February 1, 2022

File: RWDI# 2001879

RE: 1045 YATES STREET – HARRIS GREEN VILLAGE – EXTERIOR MECHANICAL NOISE REVIEW

Figure 2: Location of Southwest Louvre

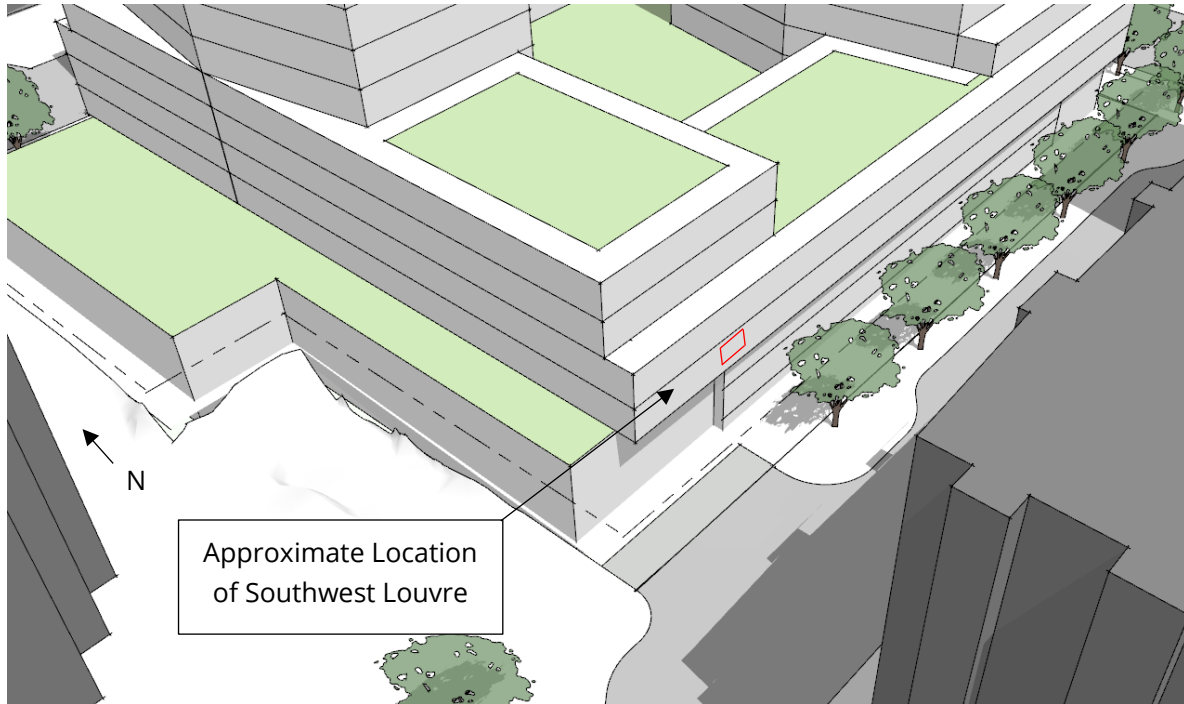
One area of interest, however, is the southwest corner of ground level structure where two make-up air units (MUA-1 and MUA-2) and two supply fans (SF-MEZZ-05 and SF-MEZZ-06) ventilate through a louver. We have determined that mitigation is required to meet the nighttime limit at the property line. Figure 2 shows the approximate location of the southwest louver.

Based on the results of our analysis, mitigation is recommended to reduce the noise impact at the southwest Louvre. We suggest the following mitigation:

1. Install 3 m lining in each of the 4 duct runs between the mechanical unit and the Southwest Louvre with minimum 25 mm thick fiberglass acoustic duct liner.
